Planning & Zoning Board Meeting

November 17, 2022 at 6:00 PM
Howey-in-the-Hills Town Hall
101 N. Palm Ave.,
Howey-in-the-Hills, FL 34737

TO: Town of Howey-in-the-Hills Planning Board
CC: J. Brock, Town Clerk
FROM: Thomas Harowski, AICP, Planning Consultant
SUBJECT: Venezia Townhouse Design Approval
DATE: November 3, 2022

TO: Howey-in-the-Hills Planning Board
CC: J. Brock, Town Clerk
FROM: Thomas Harowski, AICP
SUBJECT: 107 E. Croton Way Design Review
DATE: November 11, 2022

Exhibit B

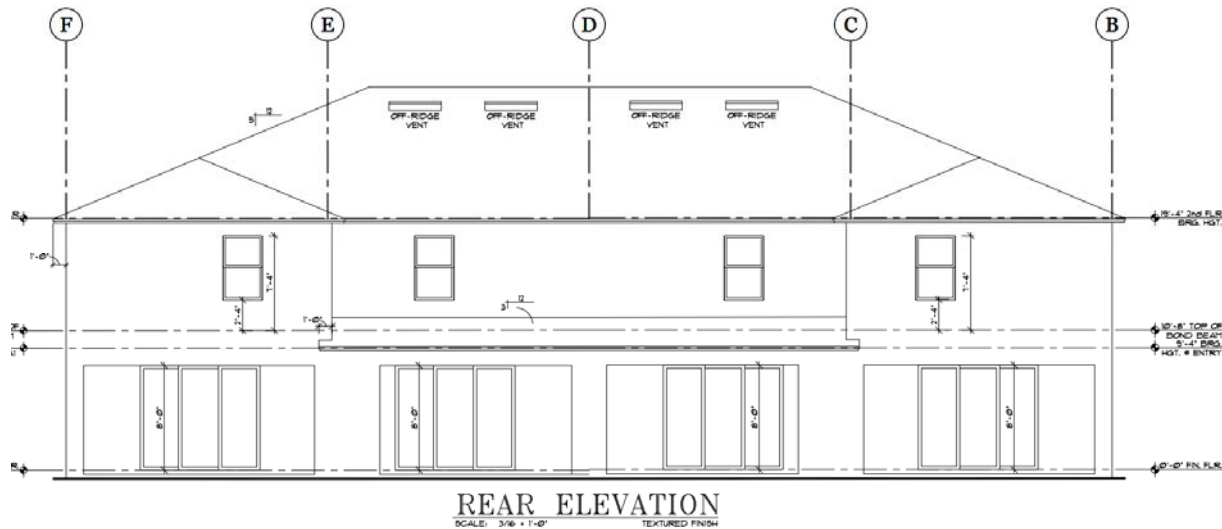
D.R. Horton has submitted a building design for the proposed 5-unit and 6-unit townhouse buildings to be constructed in the Venezia subdivision. The plans as submitted fail to meet the minimum design requirements as set forth in the final subdivision plan approval granted by the Howey-in-the-Hills Town Council at their regular meeting of February 14, 2022. The applicant needs to revise the plans and resubmit a design meeting or exceeding the minimum standards established in the approved plans. The Town Council motion for approval reads as follows:

A motion was made to “conditionally approve the Venezia Townhomes Subdivision Plan contingent on the developer ensuring the shutters and corbeling were placed around the rear windows of the six townhome buildings that have their rears backing Venezia Boulevard (as shown in Exhibit B of the Venezia Townhomes exhibit attachment of this meetings packet).”

The plans as submitted show neither the shutters nor the corbeling for either the 5-unit or 6-unit buildings. A revised submittal is required to meet at least this minimal standard. To improve the overall quality of the project this design treatment should be applied to each building in the development.

The staff recommends the Planning Board not approve the building design until plans are submitted which meet at least the minimum standard established by the Town Council final subdivision plan approval.

LEFT ELEVATION
3/16" = 1'-0"

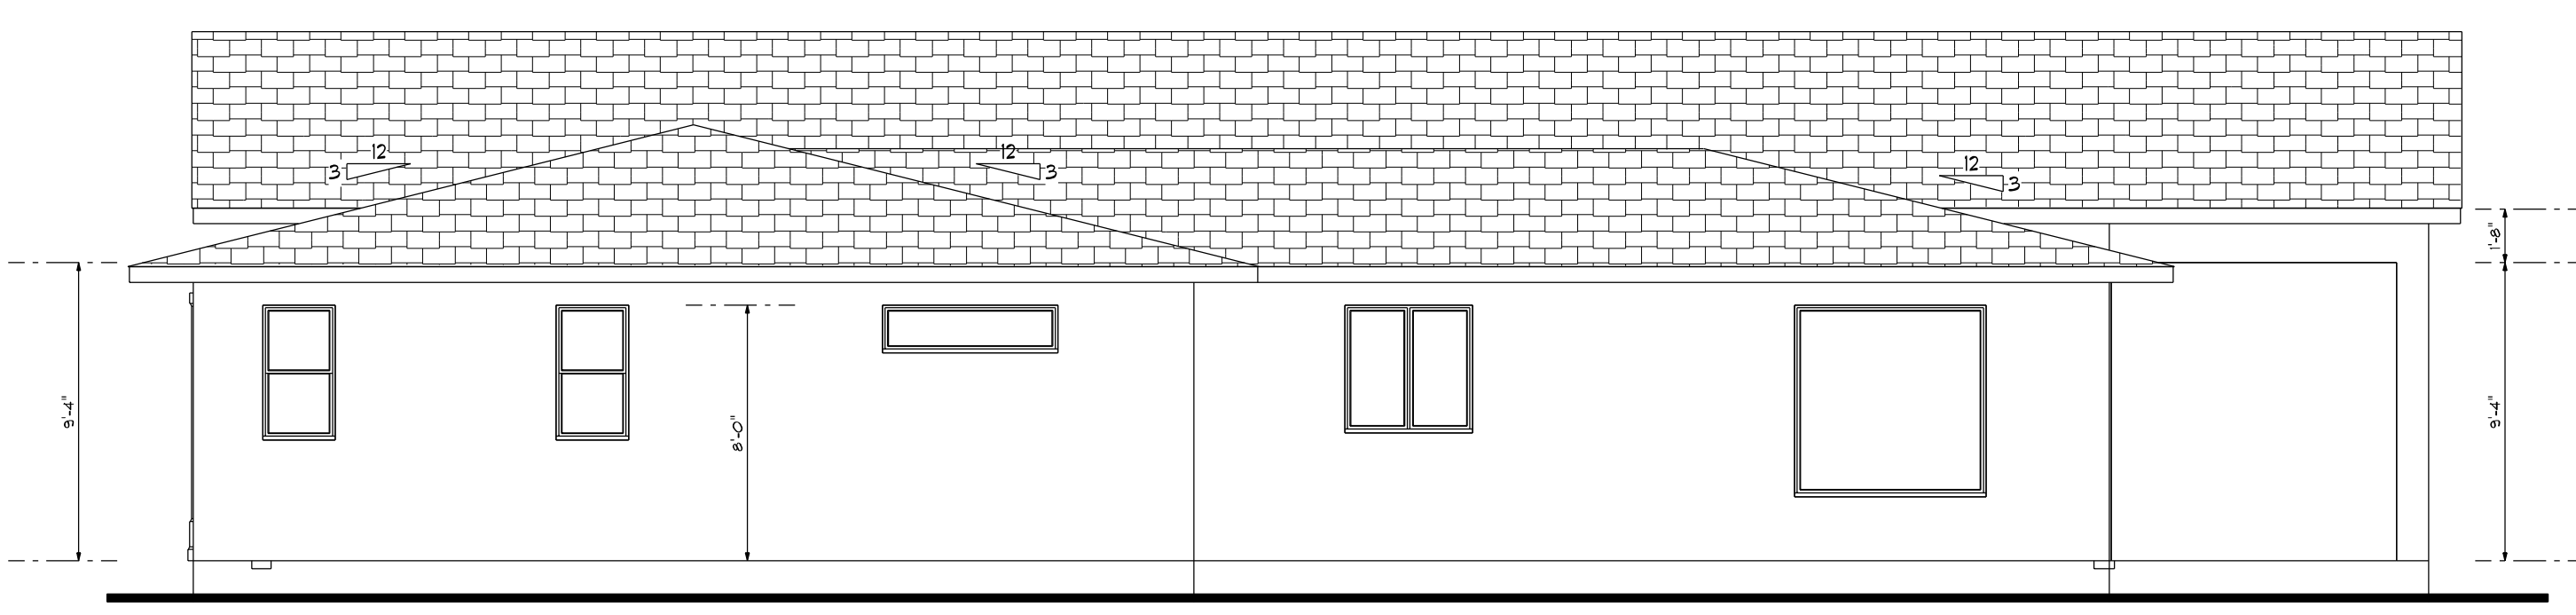
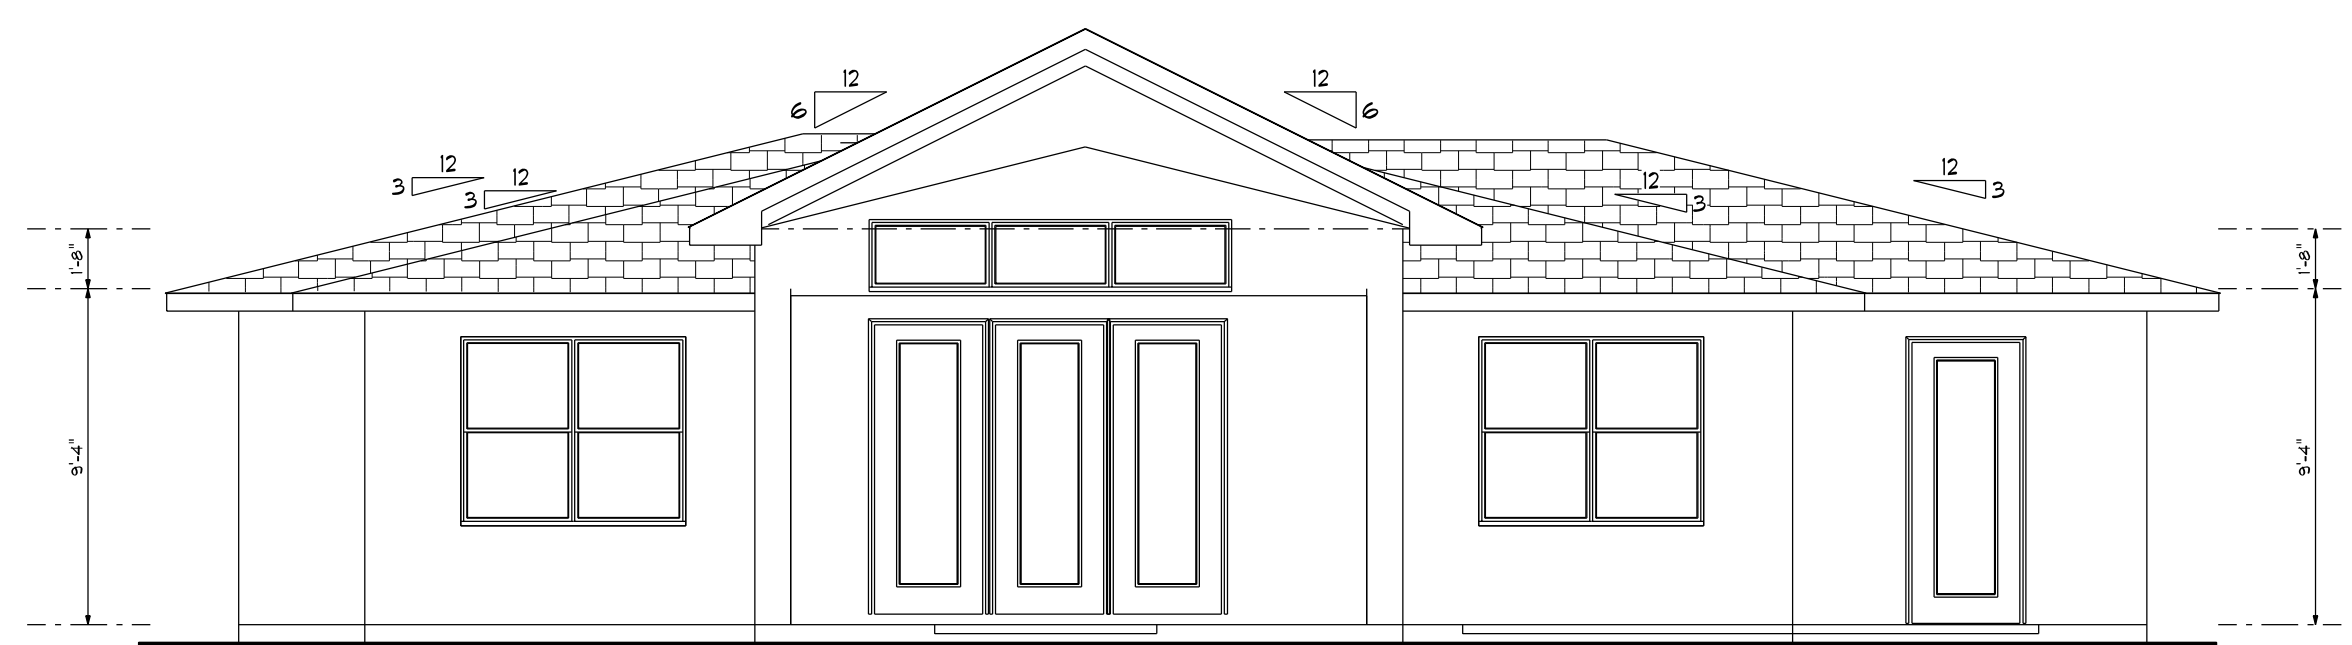
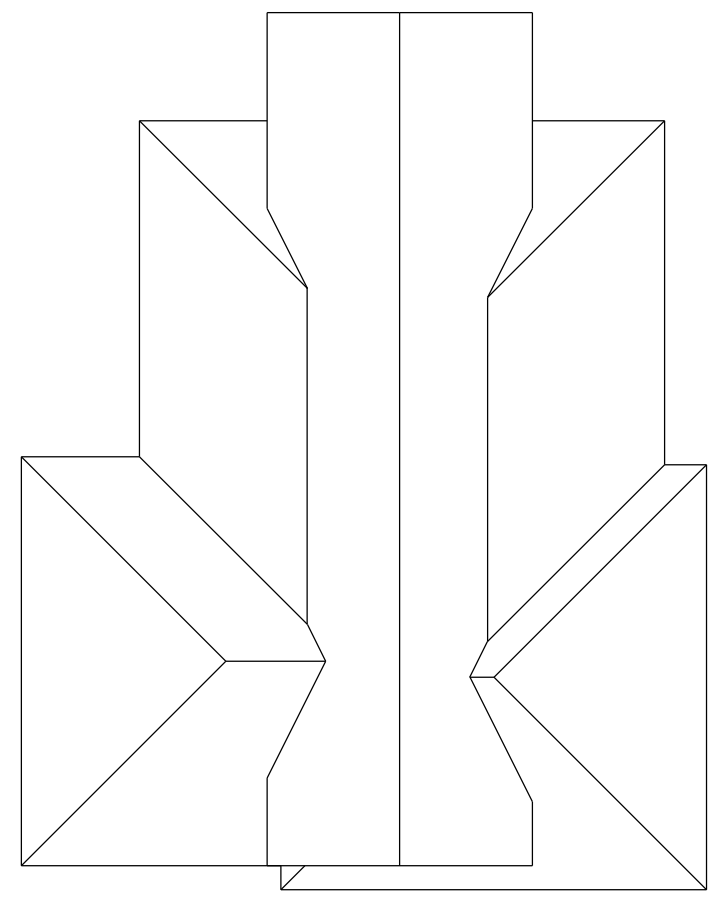
The plans for the proposed residence at 107 East Croton Way have been reviewed for compliance with the code requirements and the results are as follows:

1. The roof design uses an approved material and includes a variation in the roof line as required.
2. The design calls for stucco exterior walls which meet the wall material requirements for the rear and side walls and Hardiboard for the front façade.
3. The design includes four design elements for the front (primary) façade.
4. The design includes two architectural design elements for the secondary facades.
5. The plans do not specify the color palette, so the applicant needs to confirm that at least two colors are proposed.
6. The proposed design meets zoning requirements for building area, building height, required garage area, and minimum floor area.
7. The lot is slightly undersized for the MDR-1 zoning classification with 14,700 square feet of lot area (15,000 required) and 98 feet of lot width (100 feet
